30 June 2006

RE: TAC No. L23950, Supplemental Information for Current Amendment
USA/9269/B(U)-96 for the Model 650L Transport Package

**Model 650L
Type B(U) - 96
Transport Package**

Revision 5

FIGURE 5.a. SAMPLE SURFACE CORRECTION FACTOR DISTANCE CRITERIA

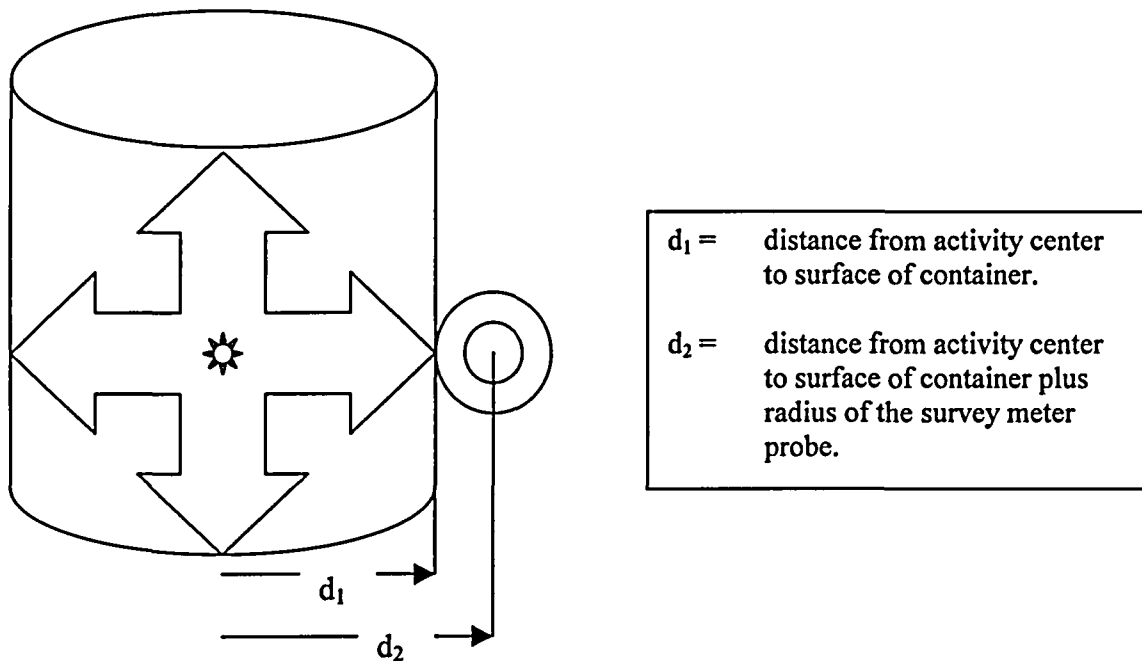
1. Section 5 has been revised to clarify the method used perform surface correction factors for newly manufactured 650L devices.
2. Tables 5.1a through 5.1c have been revised to list the 1 meter dose rate measurements in units of mSv/hr (mrem/hr) instead of the previous values of μ Sv/hr (mrem/hr). This is done for consistency with the other tables in this section.

$$SCF = \sqrt{\frac{d_2^2}{d_1^2}} \text{ where } d_1 \text{ and } d_2 \text{ are determined as shown in Figure 5.a.}$$

Therefore in the example shown, all original surface profile measurements located along the side of the device shown in Figure 5.a would also be multiplied by a factor to account for surface correction of the detector to the device. Different SCF's would be calculated for the any dimension of the container where the minimum distance from the center of the activity to the center of the radiation probe is different.
